Vermont Agency of Transportation
RECEIVED
CK'D BY JG, SC, TM   OK'D BY G. Laroche
February 15, 2016
RESUBMIT Yes   Rejected
BY K. Higgins   DATE 03/03/2016

APPROVAL STAMP:	J.P. CARRARA & SONS INC. Precast & Prestress Manufacturer 2464 CASE STR., MIDDLEBURY, VERMONT 05753 Phone:(802)388-6361 Fax:(802)388-9010	J.A. McDonald, Inc. CONTRACTOR LYNDON CENTER, VERMONT
	STATE OF VERMONT AGENCY OF TRANSPORTATION COUNTY OF RUTLAND	DATE: JAN. 8, 2016 SCALE: NOTED
	TOWN OF CLARENDON WALKER MOUNTAIN ROAD, TH #3, RURAL COLLECTOR BRIDGE NO.: 11 PROJECT NO.: BRO 1443(48)	CHKD: B.C. DFTM: T.D. JOB NO: 23476-015
	COVER SHEET	DWG. NO: C1

TOWN OF CLARENDON
WALKER MOUNTAIN ROAD, TH #3, RURAL COLLECTOR
BRIDGE NO.: 11 PROJECT NO.: BRO 1443(48)

1 NB2 DIMENSIONAL PLAN VIEW IN FORM "C-NB1"

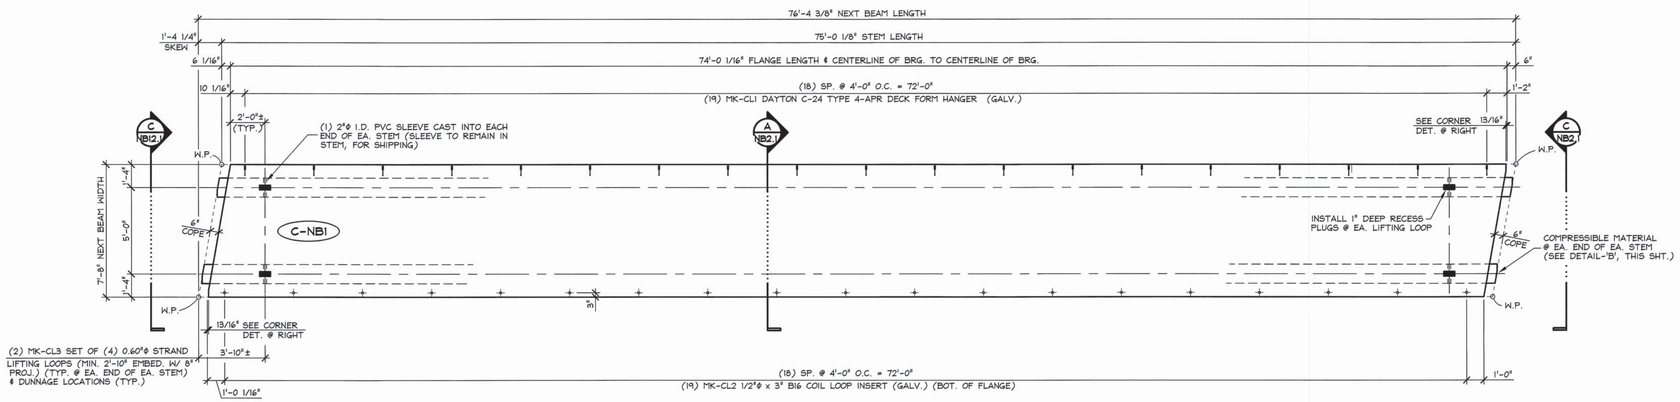
Extent of drip notch should be drawn on plan view.

Provide a dimension from Face of Flange to Working Point

2 NB2 REINFORCING PLAN VIEW IN FORM "C-NB1"

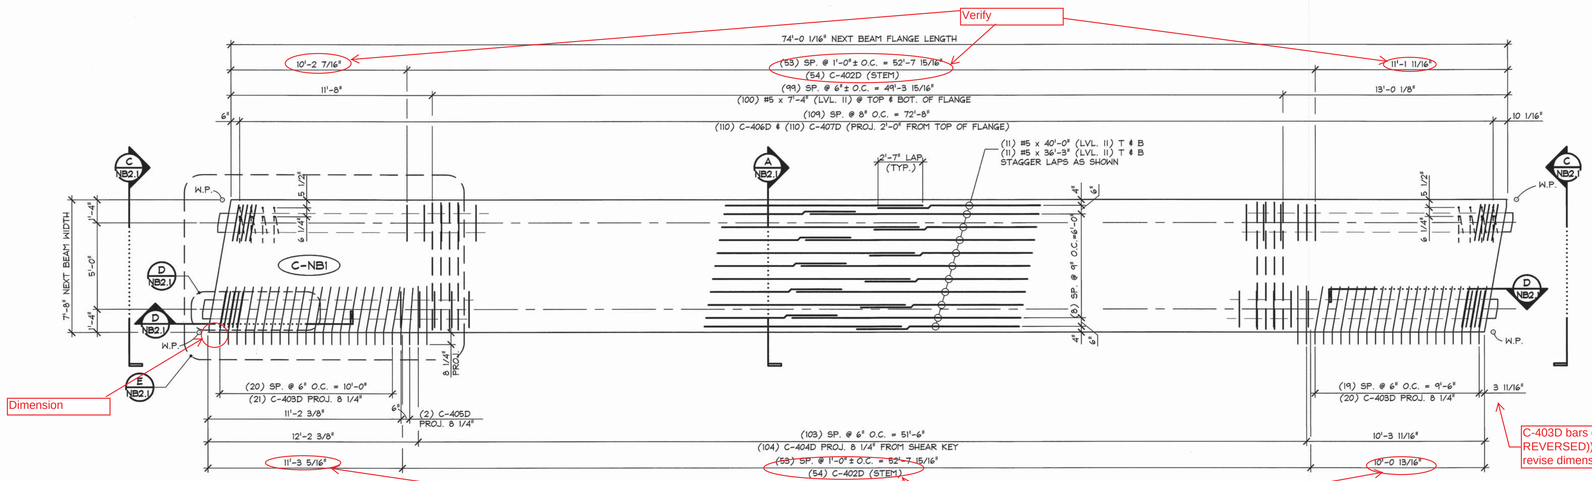
Verify

C-403D bars conflict from NB2 to (NB3, OR NB1 REVERSED)) Either Provide additional details, or revise dimensions so bars no longer conflict each

STEM PLAN

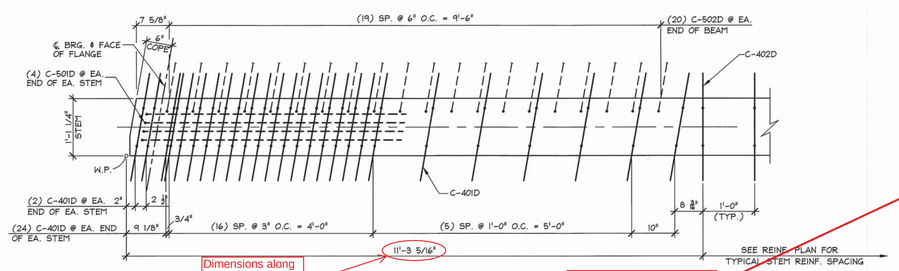
Dimensions along C-401D do not add up.

Doesn't match Enlarged Transverse Reinforcing Plan

D NB2.1 END BLOCK STEM REINFORCING DETAILS
3/4" = 1'-0"

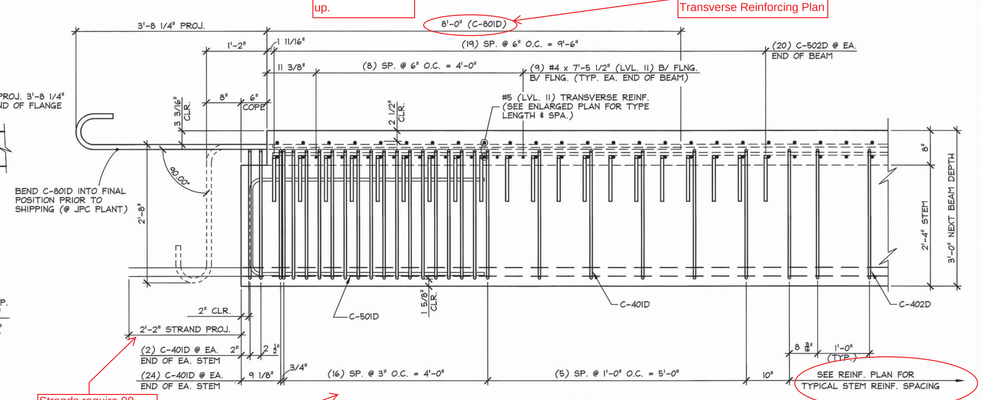
HOW WILL THE 90 DEG BEND BE ACCOMPLISHED?

Strands require 90 deg bend. Label work to be done by others.

Doesn't match Stem Plan

C-403D, C-404D, C-405D NOT DETAILED HERE AS THEY SHOULD BE. THERE IS NO MENTION THESE BARS ARE OMMITTED FOR CLARITY.

Clarify which spacing this bar is for.

Performed by others.

E NB2.1 ENLARGED TRANSVERSE REINFORCING PLAN
LONGITUDINAL REINFORCING & STEM STIRRUPS NOT SHOWN FOR CLARITY
1/2" = 1'-0"

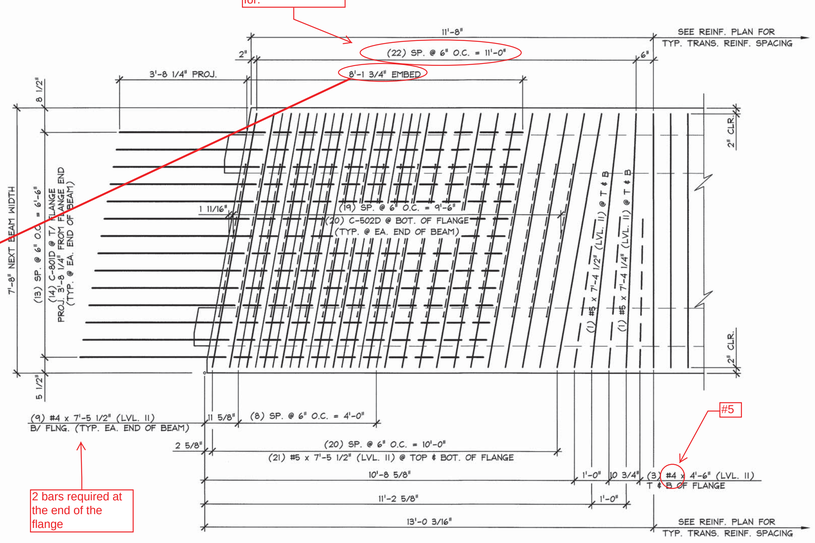
2 bars required at the end of the flange

1 AS1 PLAN VIEW IN FORM
1/2" = 1'-0"

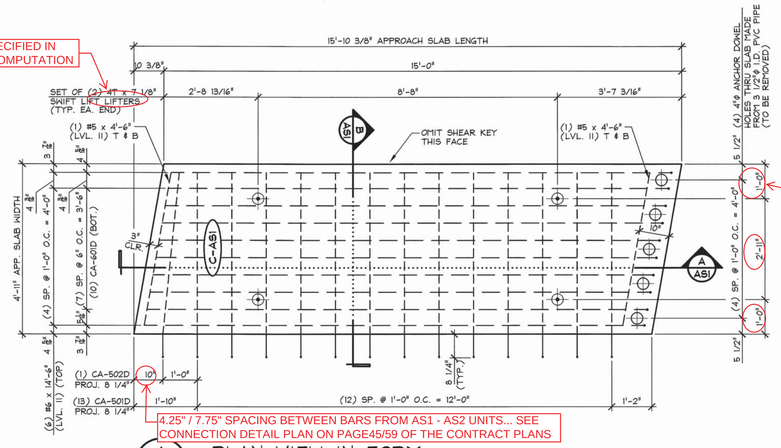
2T x 6" SPECIFIED IN LIFTING COMPUTATION

DOES NOT MEET MINIMUM EDGE DISTANCE OF 13" FOR 2T x 6" LIFTING DEVICE AS SPECIFIED

4.25" / 7.75" SPACING BETWEEN BARS FROM AS1 - AS2 UNITS... SEE CONNECTION DETAIL PLAN ON PAGE45/59 OF THE CONTRACT PLANS

B AS1 SECTION
1" = 1'-0"

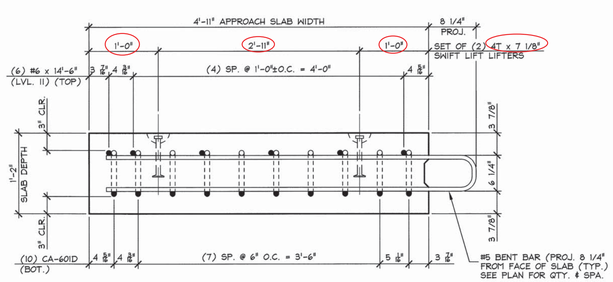
1/8" coarse aggregate rim exposed

LABEL THE FINISH REQUIRED... REFERENCE PROJECT NOTE 63. EXPOSED AGGREGATE 1/8" MINIMUM AMPLITUDE

1 / AS2 PLAN VIEW IN FORM
1/2" = 1'-0"

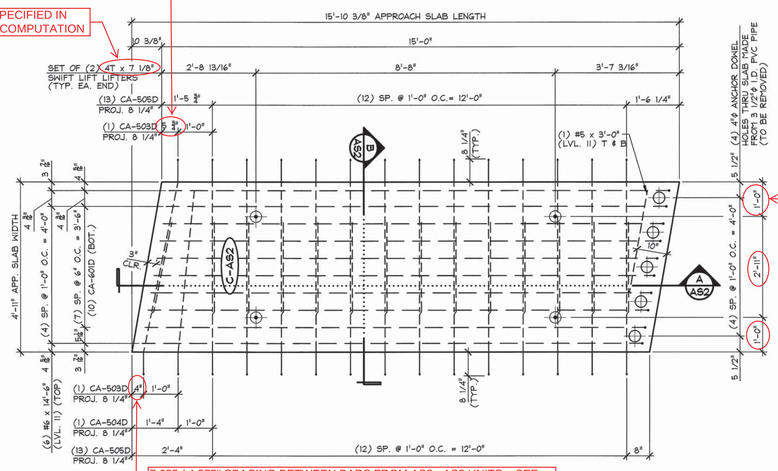
4.25" / 7.75" SPACING BETWEEN BARS FROM AS1 - AS2 UNITS... SEE CONNECTION DETAIL PLAN ON PAGE45/59 OF THE CONTRACT PLANS

2T x 6" SPECIFIED IN LIFTING COMPUTATION

7.625 / 4.375" SPACING BETWEEN BARS FROM AS2 - AS3 UNITS... SEE CONNECTION DETAIL PLAN ON PAGE45/59 OF THE CONTRACT PLANS

B / AS2 SECTION
1" = 1'-0"

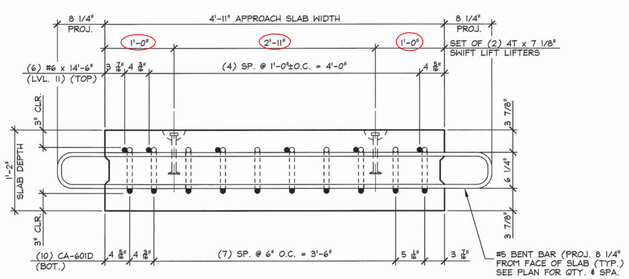
LABEL THE FINISH REQUIRED... REFERENCE PROJECT NOTE 63. EXPOSED AGGREGATE 1/8" MINIMUM AMPLITUDE

1 AS4 PLAN VIEW IN FORM
1/2" = 1'-0"

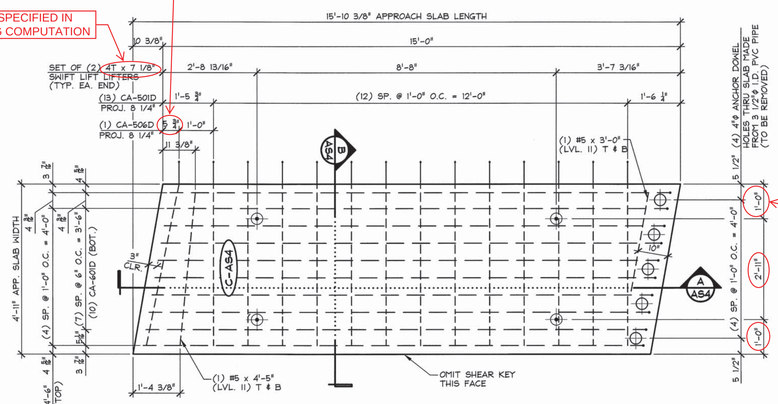
4.25" / 7.75" SPACING BETWEEN BARS FROM AS3 - AS4 UNITS... SEE CONNECTION DETAIL PLAN ON PAGE45/59 OF THE CONTRACT PLANS

2T x 6" SPECIFIED IN LIFTING COMPUTATION

DOES NOT MEET MINIMUM EDGE DISTANCE OF 13" FOR 2T x 6" LIFTING DEVICE AS SPECIFIED

B AS4 SECTION
1" = 1'-0"

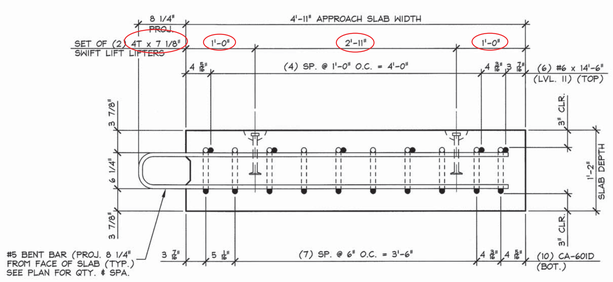
LABEL THE FINISH REQUIRED... REFERENCE PROJECT NOTE 63. EXPOSED AGGREGATE 1/8" MINIMUM AMPLITUDE
